TOSHIBA Microcontrollers TLCS-870 Family TLCS-870/C1 Series

Restrictions on the Voltage Detection Circuit

Datasheet Corrections: Electrical Characteristics of the Power-On Reset Circuit

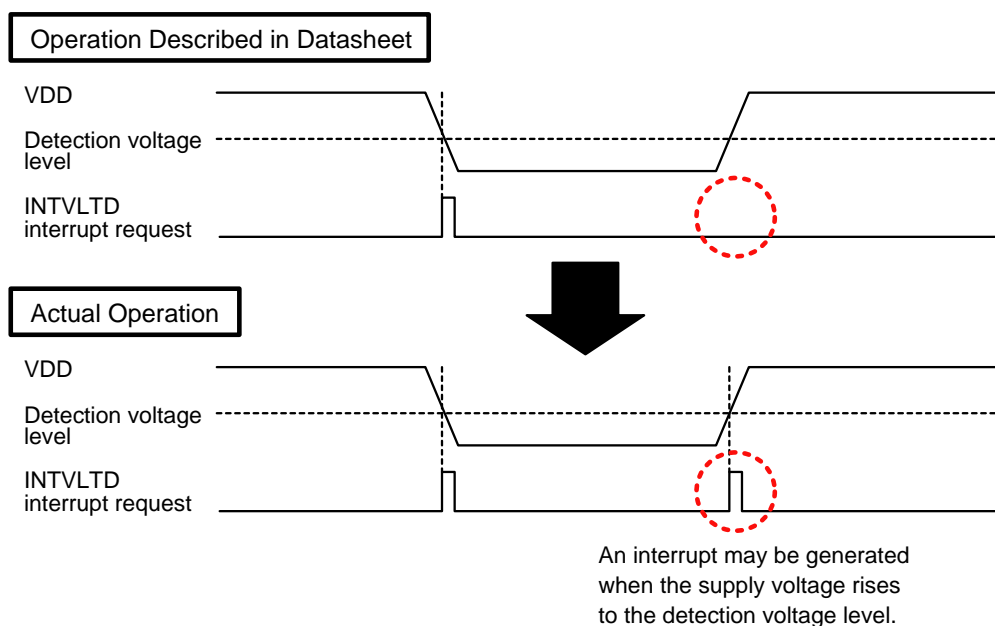
1. INTVLTD Interrupt Request

When interrupt generation is enabled in the voltage detection circuit, an INTVLTD interrupt request may be generated not only when the supply voltage falls to the detection voltage level, but also when it rises to the detection voltage level.

In ICE mode of the In-Circuit Emulator (TMP89C900), no interrupt request is generated when the supply voltage rises to the detection voltage level. Therefore, with products supporting the In-Circuit Emulator (TMP89C900), the interrupt generation operation may differ between the development tool and the actual product.

2. Releasing STOP Mode by Voltage Detection

The SRSS bit in the voltage detection control register 2 (VDCR2) provided for releasing STOP mode by voltage detection cannot be used because it does not function as expected.

Do not use the INTVLTD interrupt for voltage detection. The voltage level should be regularly checked using other timing such as the execution cycle of the main program. VDCR1<VDxSF> (x=1, 2) can be used to check the voltage level. However, if the operating voltage is near the detection voltage, the VDCR1<VDxSF> value may become unstable. It is recommended that VDCR1<VDxSF> be tested multiple times to determine the voltage level.

Always set VDCR2<SRSS> to "00". Use the STOP pin to release STOP mode.
